**STAFF REPORT**  
**KETCHUM PLANNING AND ZONING COMMISSION**  
**REGULAR MEETING OF MARCH 28, 2023**

**PROJECT:** Leadville Trading

**APPLICATION TYPE:** Final Design Review and Conditional Use Permit (CUP)

**REQUEST:** Design Review application for the development of a new 6,039 square foot two story commercial development and Conditional Use Permit for three on-site parking spaces.

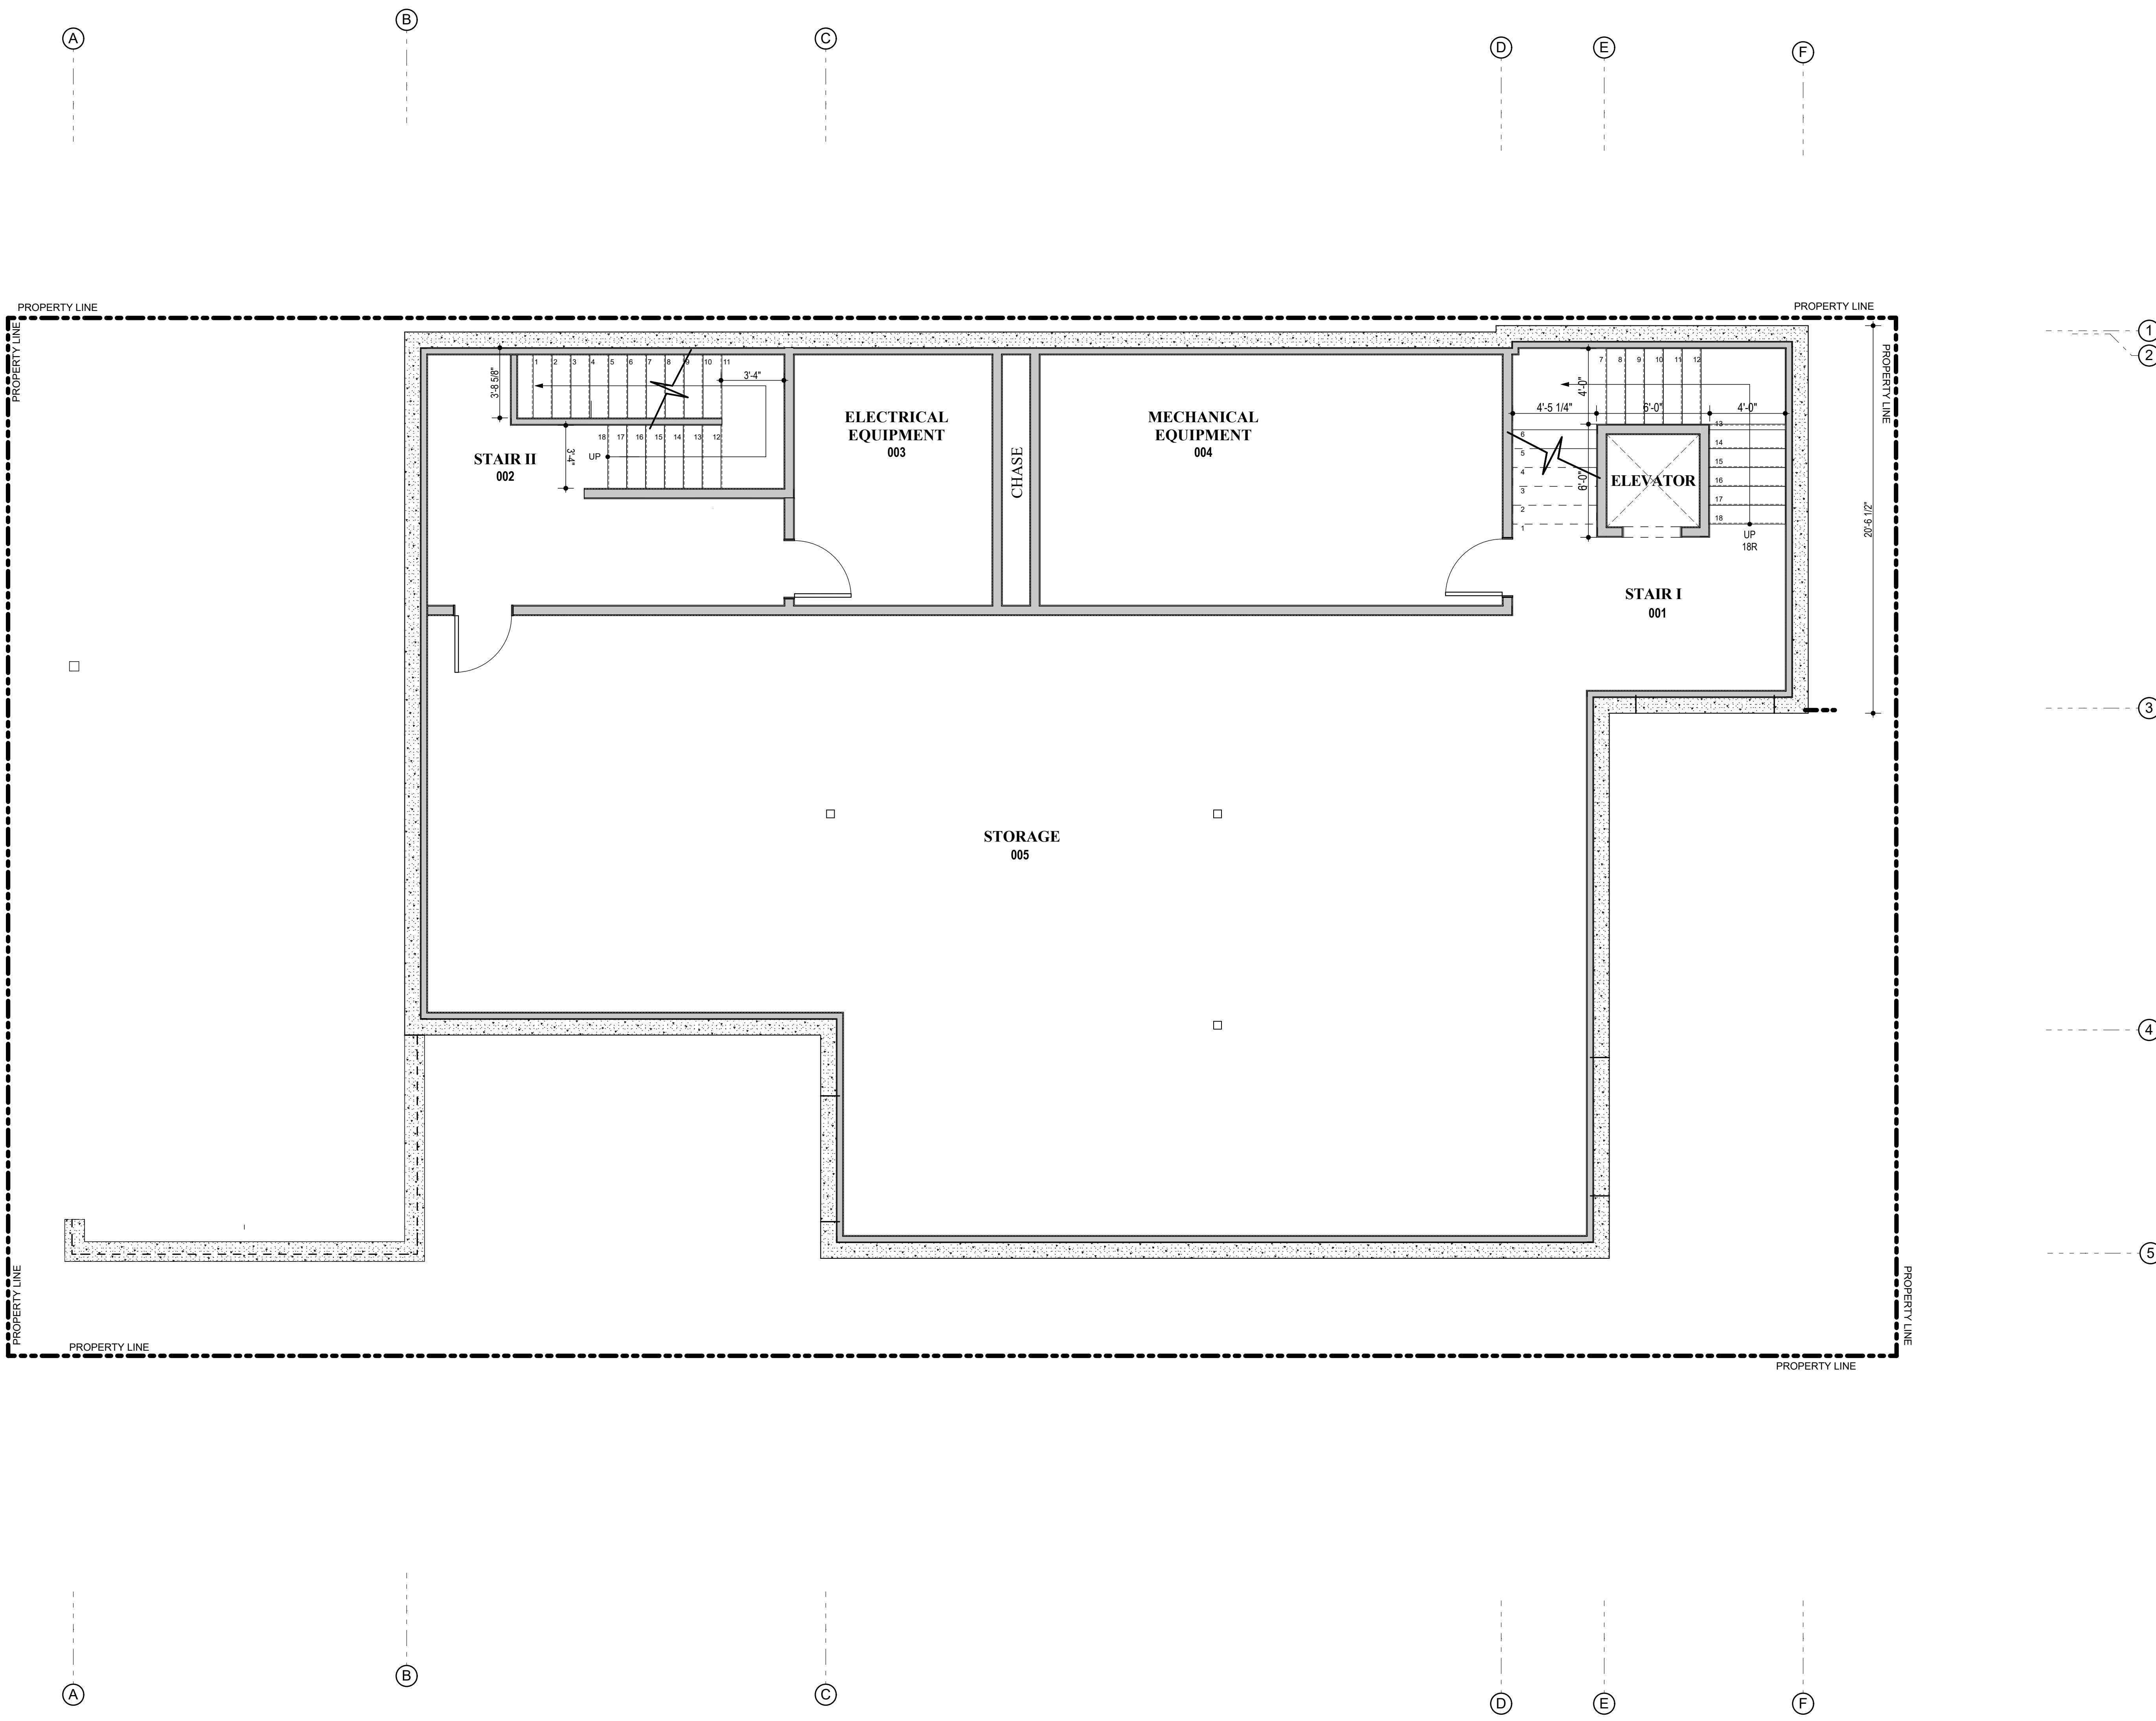
The proposed project meets all the requirements of the zoning regulations except for setbacks of mechanical equipment from building facades. Per KMC 17.12.040, non-habitable structures, fixed amenities, solar and mechanical equipment affixed to a roof must be set back 10 feet from all building facades. As shown on the roof plan (Sheet A2.3), there are two areas designated for mechanical equipment that will be screened with metal paneling at a max height of 5 feet. The mechanical areas proposed vary in setback from 5-10 feet depending on the façade. The applicant has been notified of this issue and fully intends to comply with the code requirements. Staff recommends the applicant revise the roof plan prior to approval of the findings of fact should the project move forward.

Sheet A2.3 shows two areas for the placement of mechanical equipment that does not conform to the setback requirements. Staff recommends a condition of approval that requires the rooftop mechanical systems be revised to meet the code required 10 foot setback from all building facades. This will be required for review and approval prior to building permit issuance.
<input checked="" type="checkbox"/>	<input type="checkbox"/>	<input type="checkbox"/>	<b>17.12.030</b>	<b>Building Height</b>
			<b>Staff Comments</b>	<p><b>Permitted:</b> 42 feet</p> <p>Height of building/CC District: The greatest vertical distance of a building in the community core district measured by determining the average elevation of the front property line and rear property line. Draw a line from the average front or rear elevation up to the maximum building height allowed, and then draw a line at that height parallel to the front or rear property line. The resulting line establishes the highest elevation of the front or rear facade. The front or rear facade shall not extend above this line. Side facades may be stepped up or down to transition from the highest elevation of the front facade height to the highest elevation of the rear facade. One or multiple steps along the side facades are allowed, except no step shall occur within 40 feet of the front elevation or within 35 feet of the rear facade. The City shall establish the elevation points used to calculate the average elevation of the front and rear property lines (see illustration A on file in the office of the City Clerk).</p> <p>Cantilevered decks and overhangs: 8 feet above walking surface  Non-habitable structures located on building roof tops: 10 feet max  Perimeter walls enclosing roof top deck and structures: 4 feet above roof surface height  Roof top solar and mechanical equipment above roof surface: 5 feet</p> <p><b>Proposed:</b></p> <p>As shown on Sheets A3.0 and A3.1, the total building height in the rear (alley) is 30 feet. The total building height in the front (Leadville side) is 32 feet.</p> <p>Cantilevered decks and overhangs: The cantilevered deck on the Leadville Ave side is 10.5 feet from the walking surface.  Non-habitable structures located on building roof tops: n/a – there are no structures on building rooftops proposed for the project.  Perimeter walls enclosing roof top deck and structures: n/a - there are no roof top deck or structures</p>

**3 ELEVATION: SOUTH (WITH NEIGHBORING BUILDING)**  
SCALE: 1/8" = 1'-0"

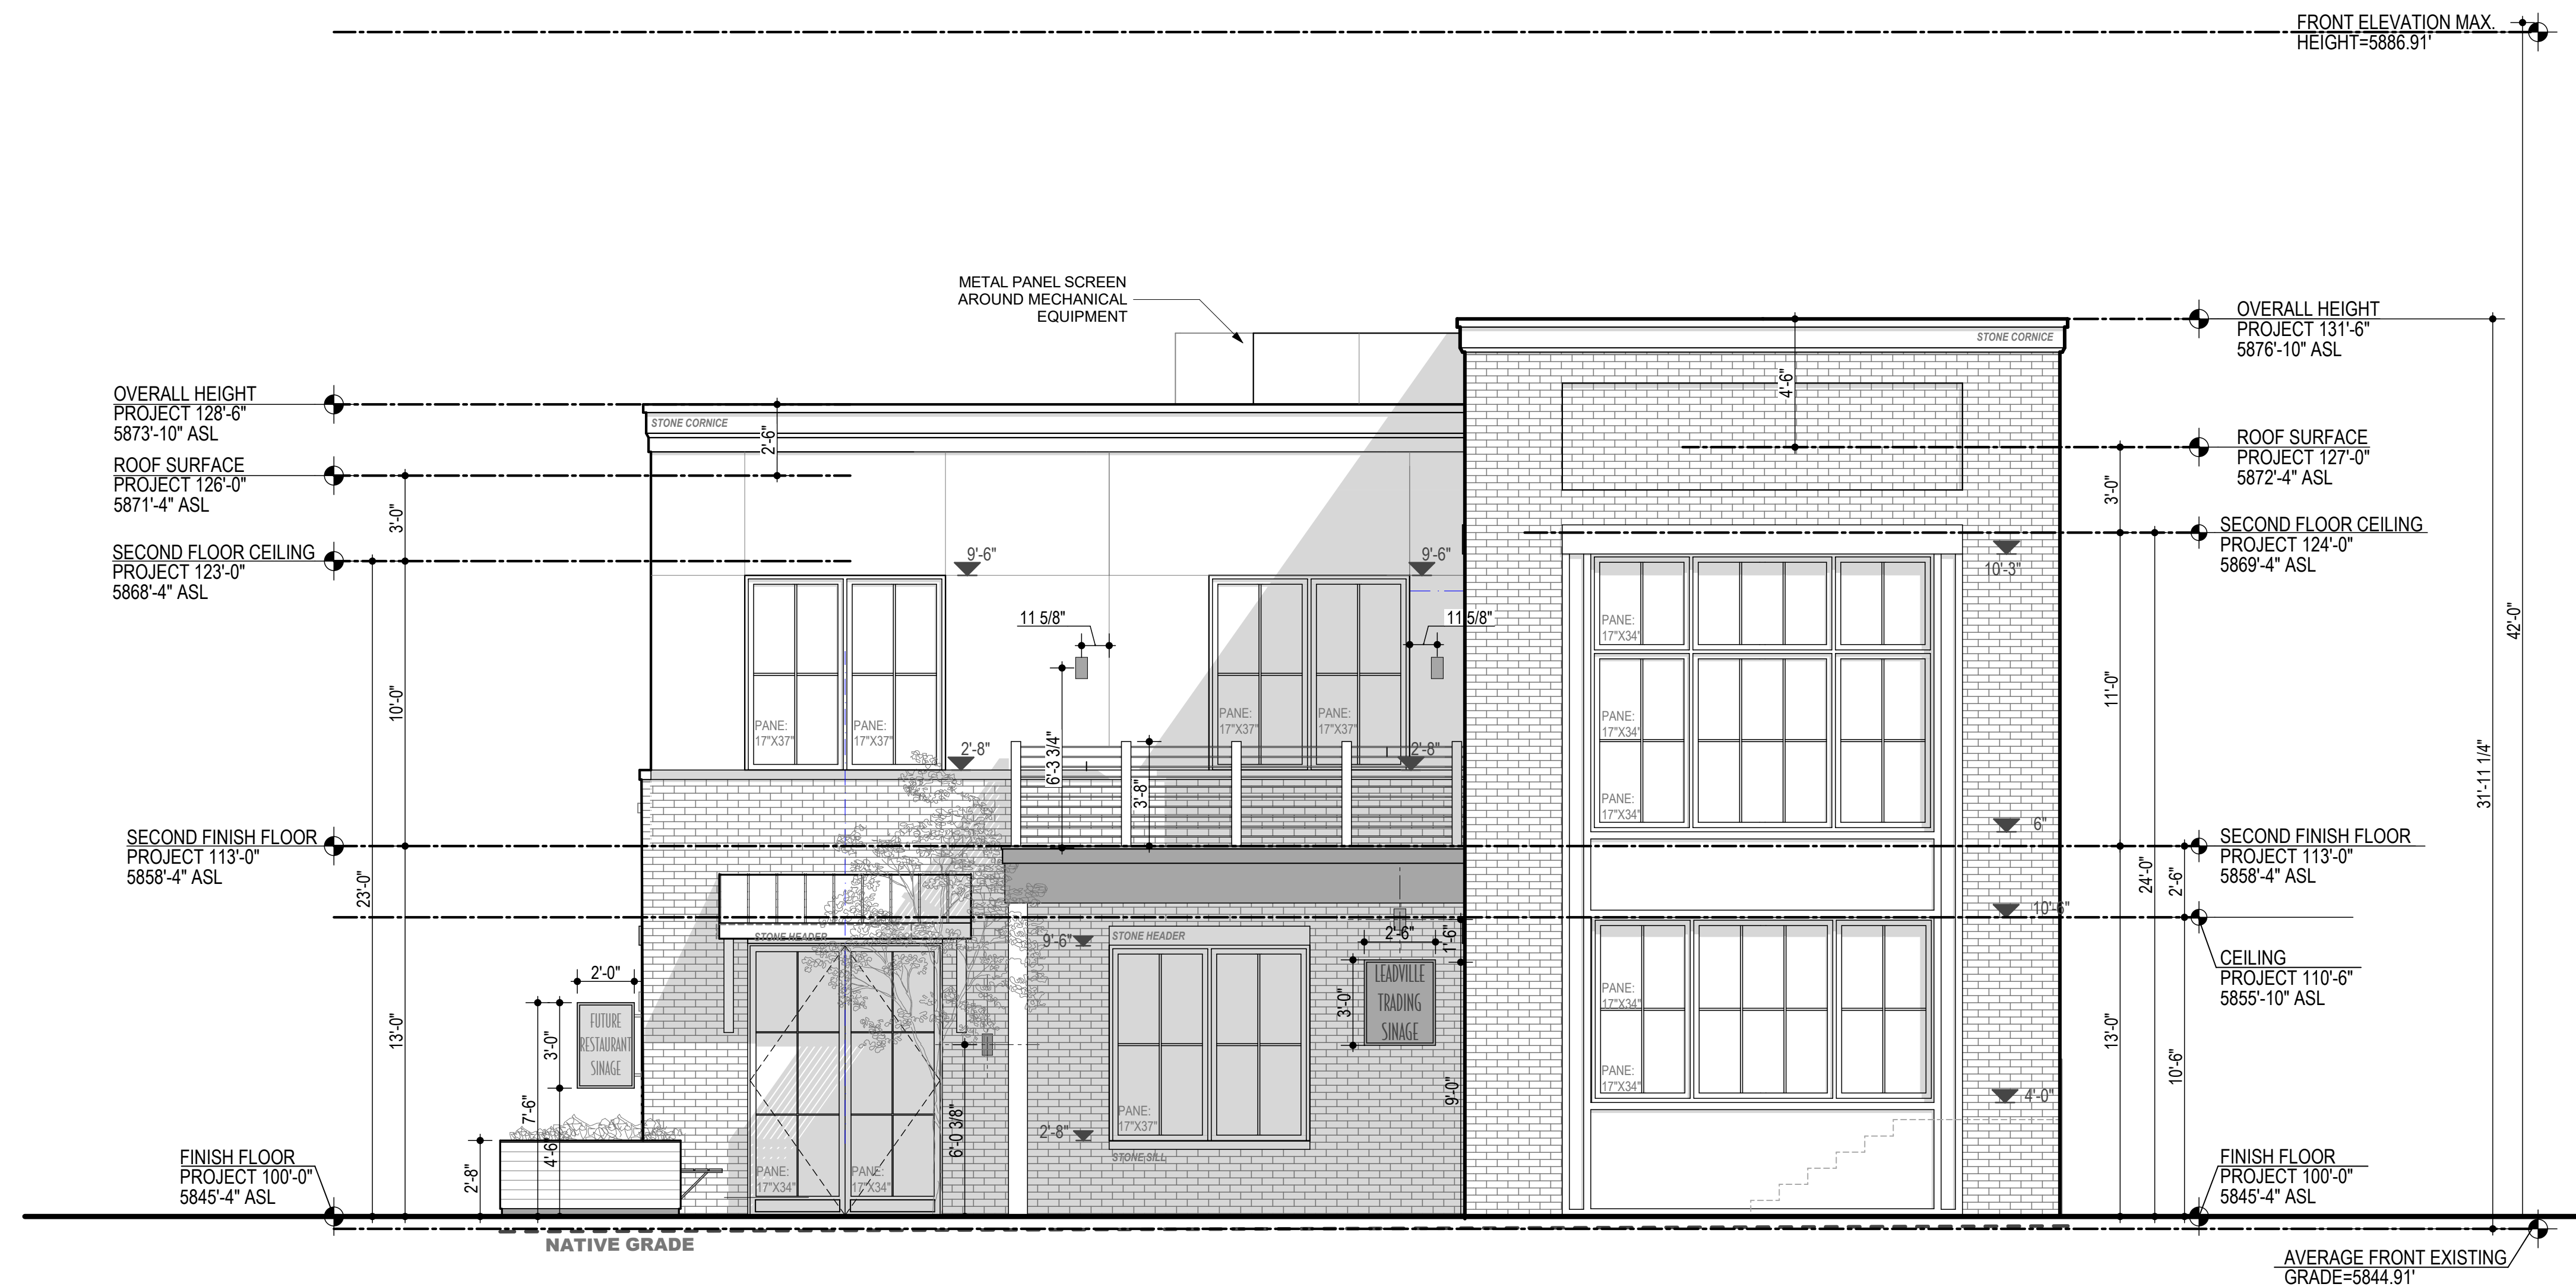
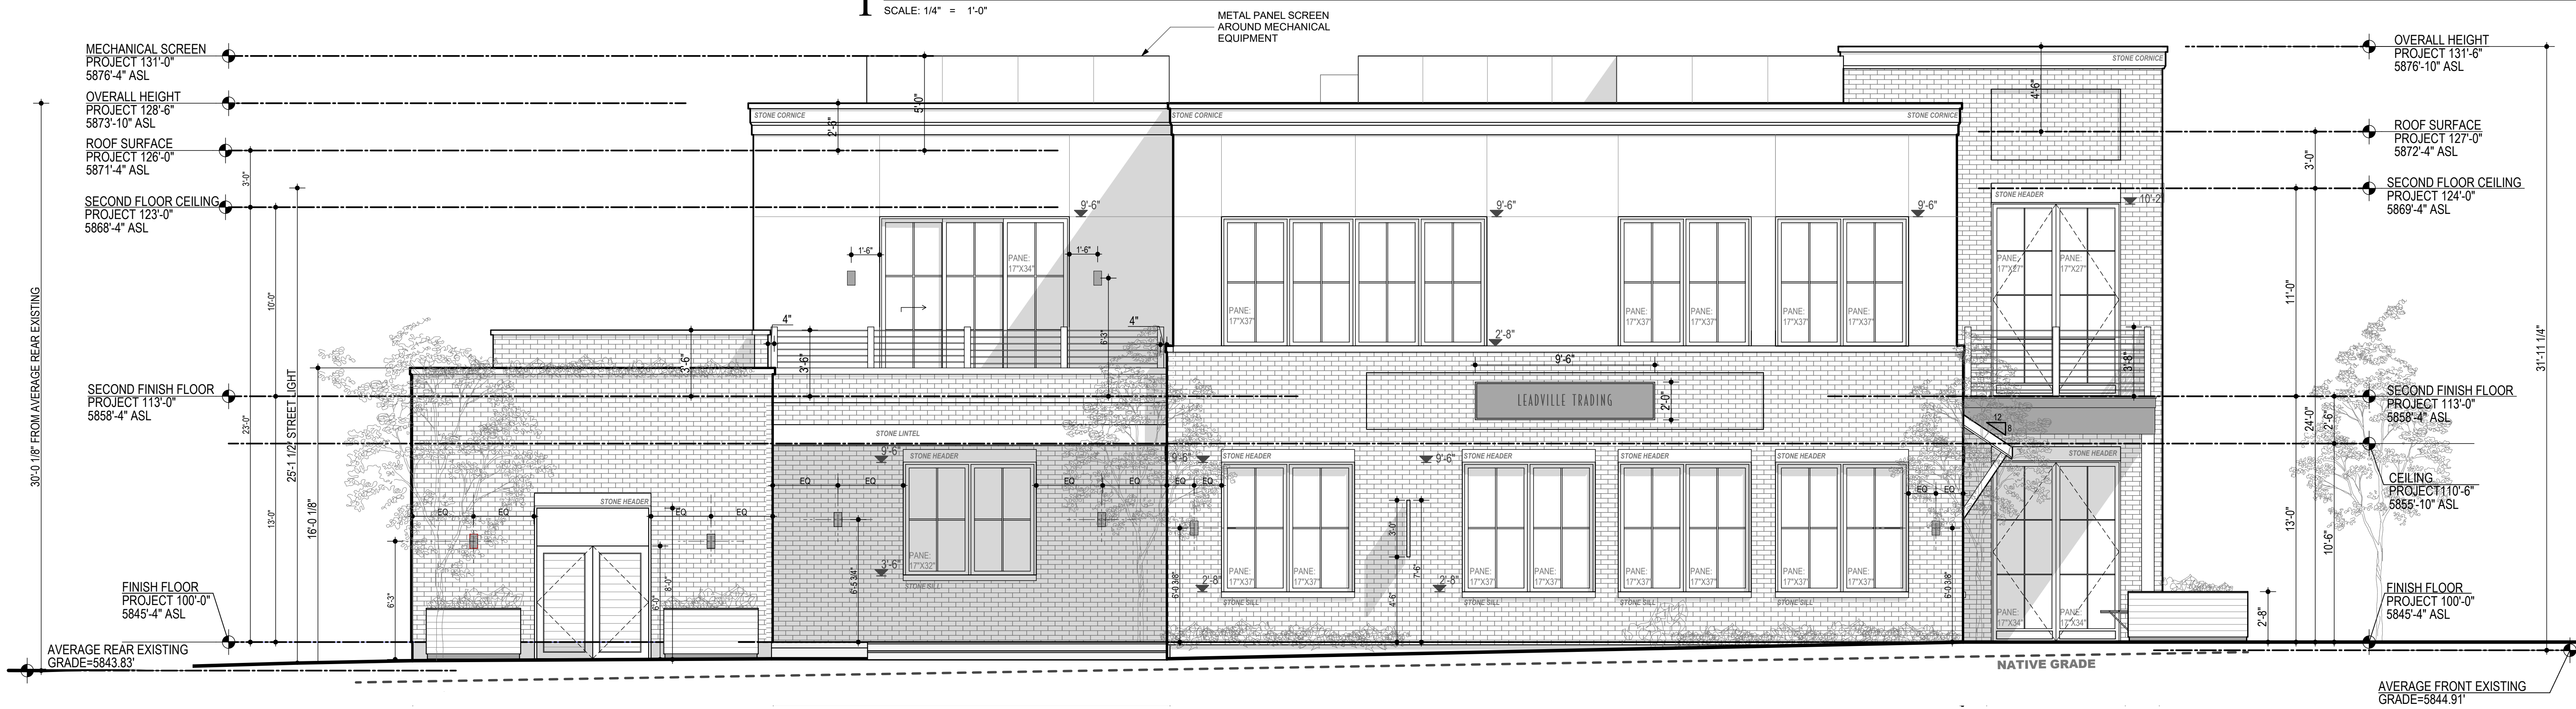
The north façade is one portion of the building is an area of discussion. As shown on the south elevation of the building on Sheet A3.1, the north façade of the building has a zero-foot setback and contains some relief provided by recessed brick elements and horizontal banding. The elevation also shows the outline of the adjacent building, Vintage Restaurant. The corner is more prominent as the proposed material wrapping the corner is brick, however, the materials quickly shift to bronze metal paneling for the remainder of the facade. This surface appears very flat and much of the building is exposed due to the size of the adjacent historic structure. As noted above, the height of the building is 30 feet in the rear and 32 feet at N Leadville Ave.

**Finding:** As shown on Sheet A3.2, the building provides undulation and relief in multiple areas. The most prominent being the staggering of the building façade on the Leadville Ave side of the building. The north end of the façade is set back 4.5 feet where the south end of the façade (towards the corner) is set back 15 feet. This is further accentuated by the inclusion of a cantilevered balcony on the Leadville Ave side. On the 2<sup>nd</sup> Street side, the building is set back a consistent 5 feet, however, there is a recessed entrance to the building that provides relief at the ground level. Additionally, the west end of the second floor is set back significantly to accommodate a second level balcony. Due to the size of the setback, this portion of the building feels much like a one story building from the pedestrian level. The north façade is one portion of the building that staff has concerns. As shown on the south elevation of Sheet A3.1, the north façade of the building has a zero-foot setback and contains minimal relief. The corner is more prominent as the proposed material wrapping the corner is brick, however, the materials quickly shift to bronze metal paneling. This surface appears very flat and much of the building is exposed due to the size of the adjacent historic structure. The elevation on Sheet A3.1 shows the outline of the adjacent building, Vintage Restaurant.
